Problems with NACK REGISTER_ACK in Figure 77-22/77-28 state diagrams

Marek Hajduczenia (marek.hajduczenia@zte.com.cn)

ZTE Corporation

NACK in Figure 77-22

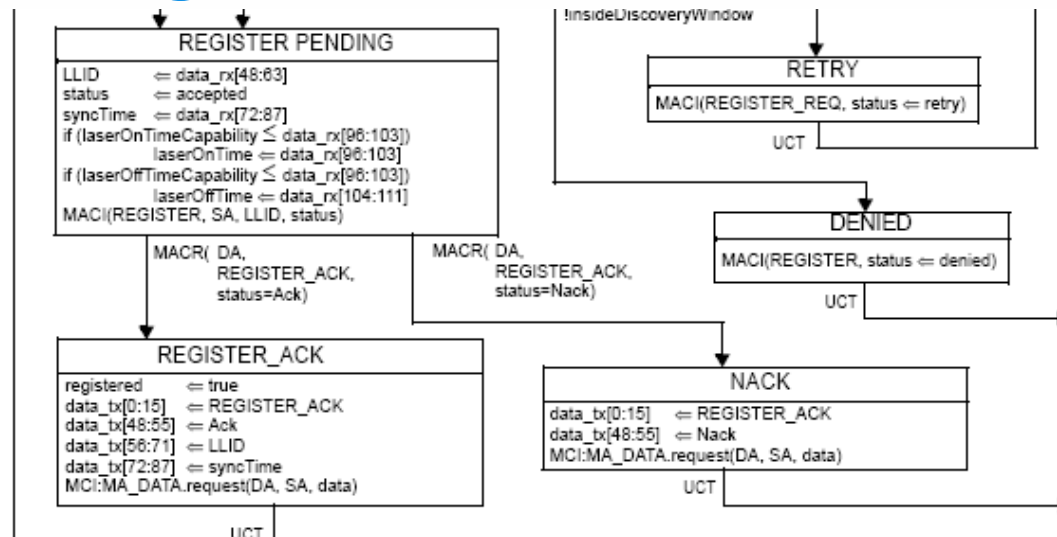
- From REGISTER_PENDING state, state diagram transitions to REGISTER_ACK / NACK state, depending on Ack / Nack from DBA agent.
- If Nack is received, state diagram moves to NACK state to send REGISTER_ACK with NACK flag enabled to indicate that registration is refused. Variable „registered” is set to false.
- OLT sends a regular GATE MPCPDU to allow ONU to send REGISTER_ACK MPCPDU – otherwise, discovery process times out

Figure 77-28 state diagram

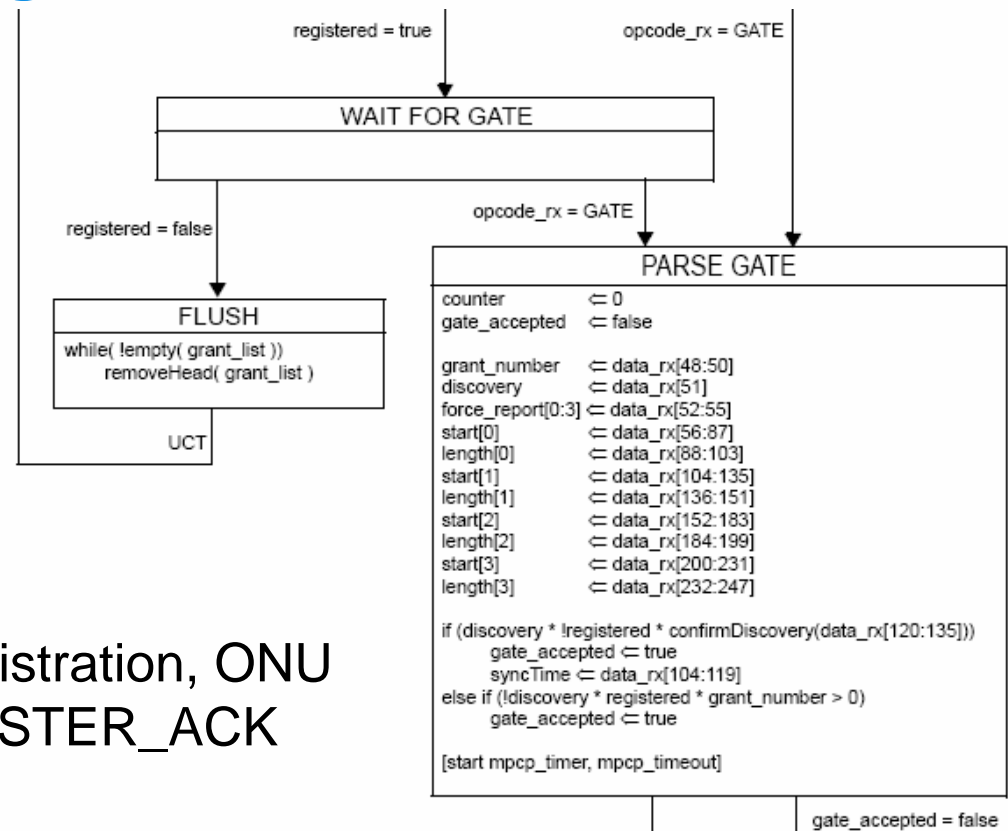
- During Discovery Process, all grant frames are transmitted using regular GATE MPCPDU (except Discovery grant)
- ONU receives regular grants when variable „registered” is true
- If ONU DBA client denies registration, ONU will not be able to send REGISTER_ACK MPCPDU
- State diagram 77-28 needs to be extended to accommodate NACK condition to transition to INCOMING_GRANT state (not shown)

- If NACK is received from ONU DBA client, **registered** is false
- If **registered** is false and a regular (non-discovery) GATE MPCPDU is received, according to Figure 77-28, such a GATE is dropped
 - if (**discovery** * !**registered** * **confirmDiscovery**(data_rx[120:135]))
 - gate_accepted ← true
 - syncTime ← data_rx[104:119]
 - else if (!**discovery** * **registered** * grant_number > 0)
 - gate_accepted ← true
- This means that an ONU cannot transmit REGISTER_ACK with NACK flag set to OLT
- Figure 77-28 and Figure 77-22 state diagrams need extension to signal NACK state in discovery process on ONU side

Figure 77-22

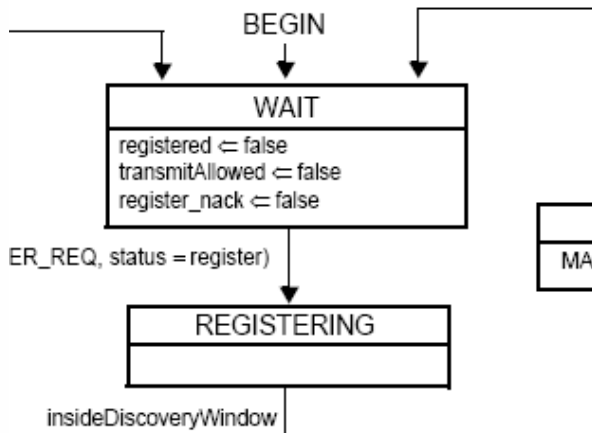
- Modify Figure 77-22 as depicted on slide 6

- add „**register_nack** <= false” in state **WAIT**
- add „**register_nack** <= true” in state **NACK**

Figure 77-28

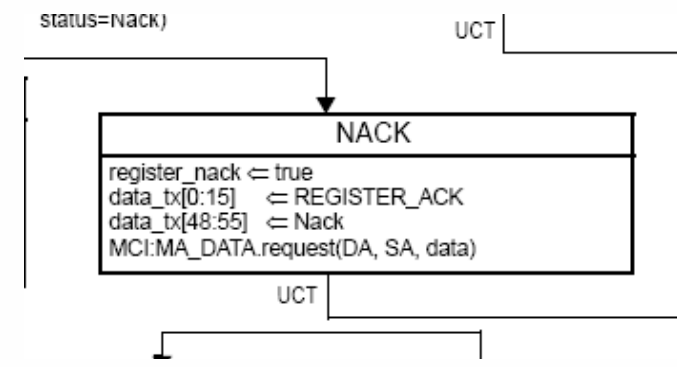
- Modify Figure 77-28 as depicted on slide 6

- modify condition

„else if (!discovery * **registered** * grant_number > 0)”
to read

„else if (!discovery * (**registered + register_nack**) * grant_number > 0)”

[register] ← data_tx[232:247]
    if (discovery * !registered * confirmDiscovery(data_rx[120:135]))
        gate_accepted ← true
        syncTime ← data_rx[104:119]
    else if (!discovery * (registered + register_nack) * grant_number > 0)
        gate_accepted ← true
    [start mpcp_timer, mpcp_timeout]
    gate_accepted = false
